RE: 136 Riverside Ave
Site Plan & Special Permit Application

As discussed, attached please find revised plans to address issues the Driscoll family has raised:

P&Z SUBMISSION
 PLANTING PLAN

SITE DEVELOPMENT PLAN
DEPICTING
136 RIVERSIDE AVENUE
WESTPORT, CT
PREPARED FOR
COASTAL LUXURY HOMES

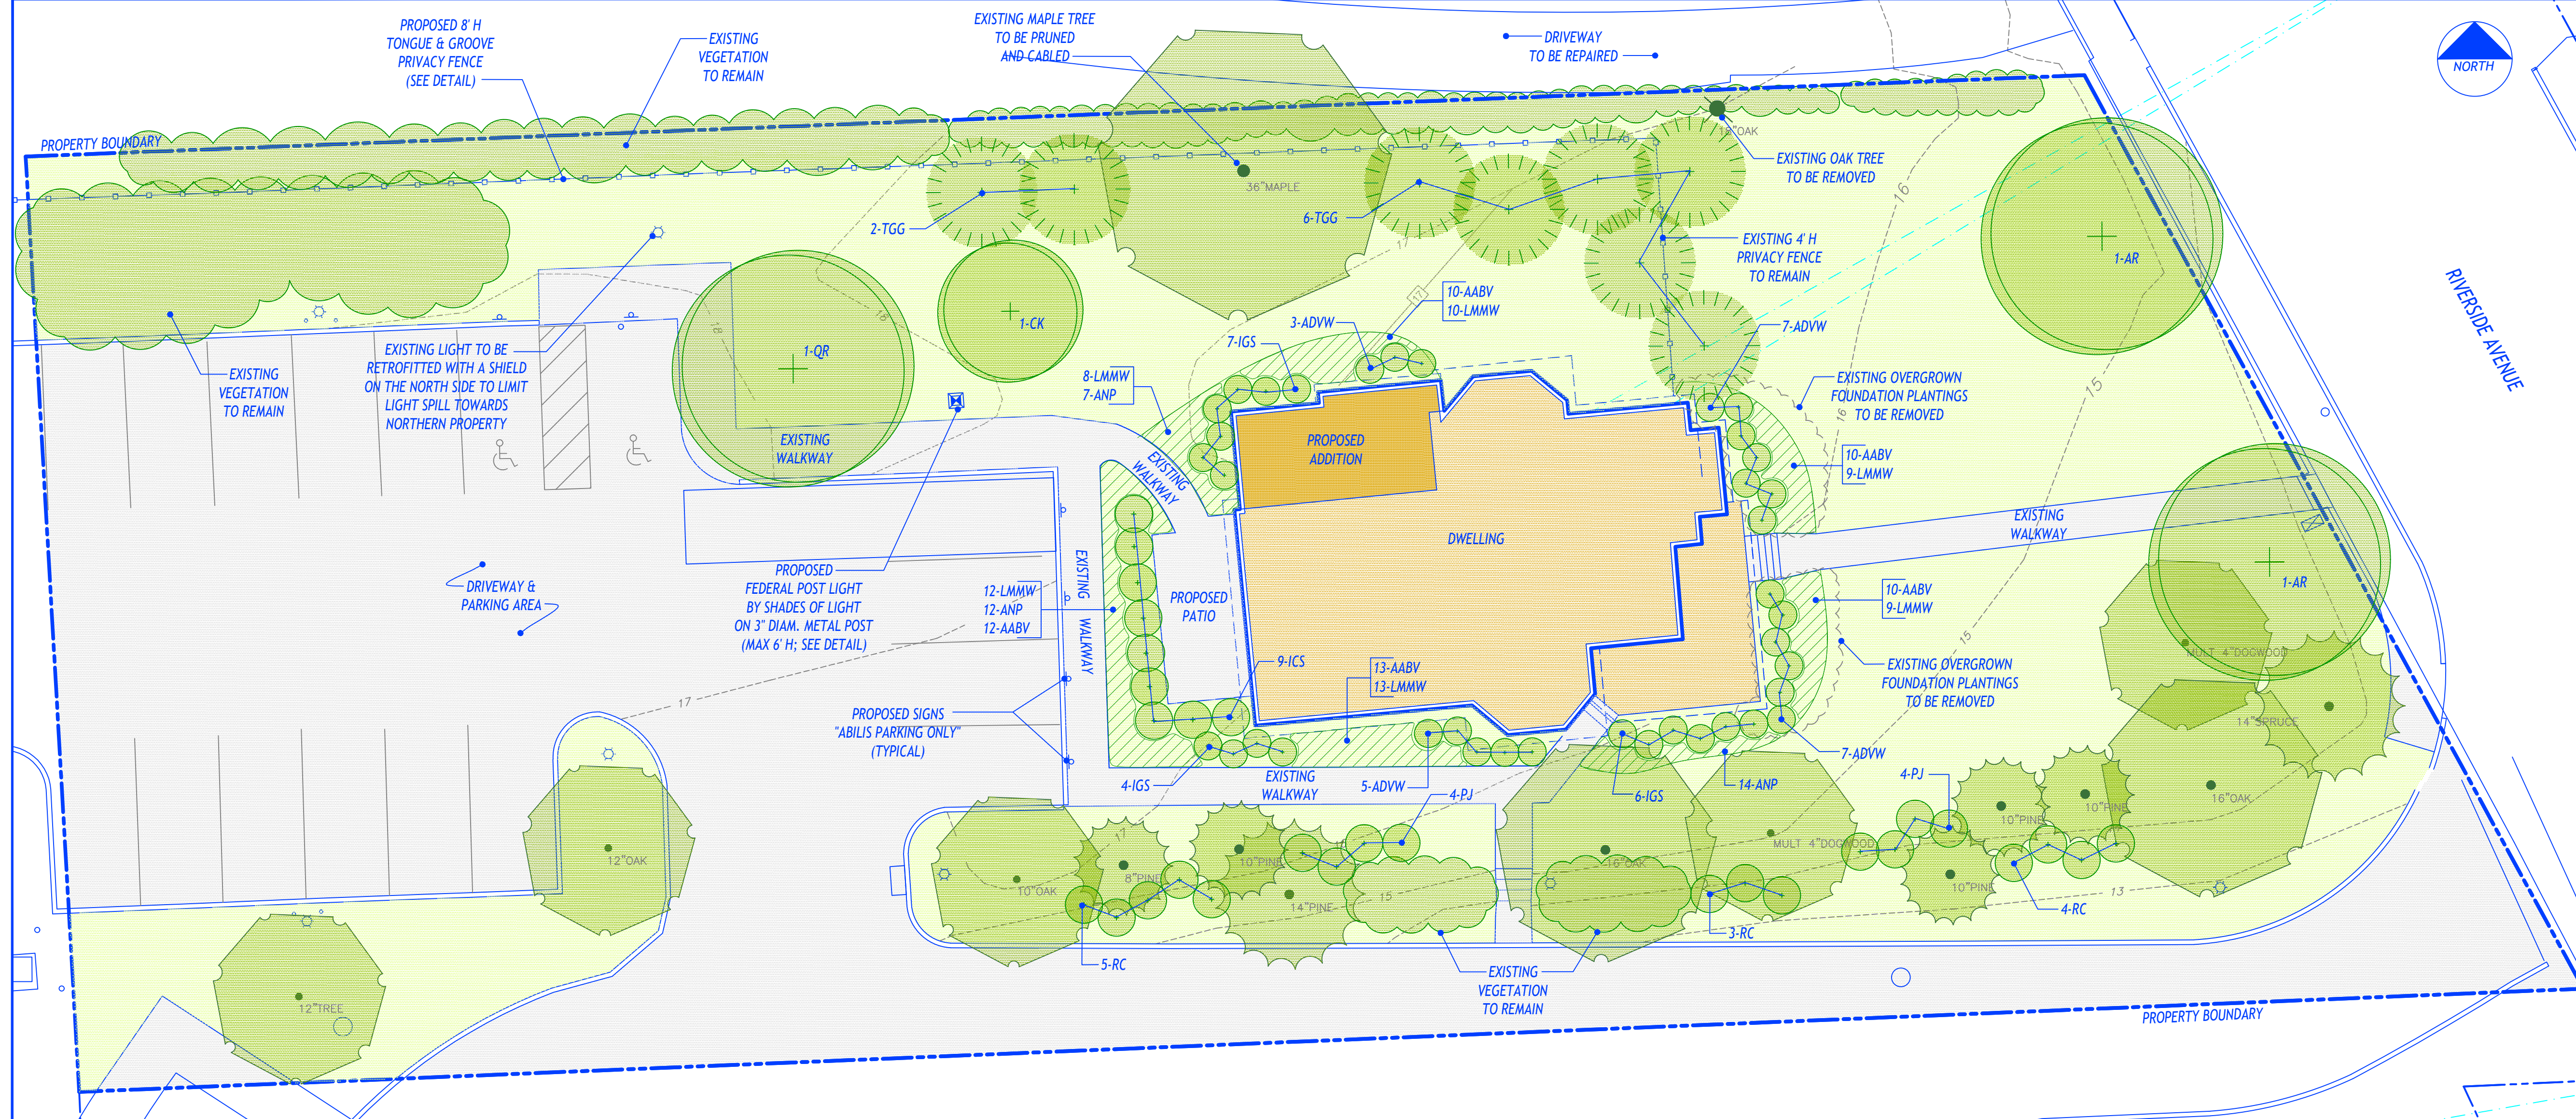
1. Relocate the patio away from their property;
2. Replace northern fence with a 8-foot-tall fence (similar to what exist);
3. Remove existing oak tree along the northern property line that causes damage to their driveway (Request being made to the town since town owns land. The applicant is willing to fix their driveway however, this is offsite and not part of our application);
4. Replace light pole by 4 parking spaces with residential style 6' tall light pole;
5. Add shielding to existing light by HC parking space;
6. Add signage to 6 spaces for "Abilis Parking Only";
7. Relocate the proposed tree line to allow for better site distances on their property; and
8. Trim the large tree overhanging on their property and cable the main trunks together.
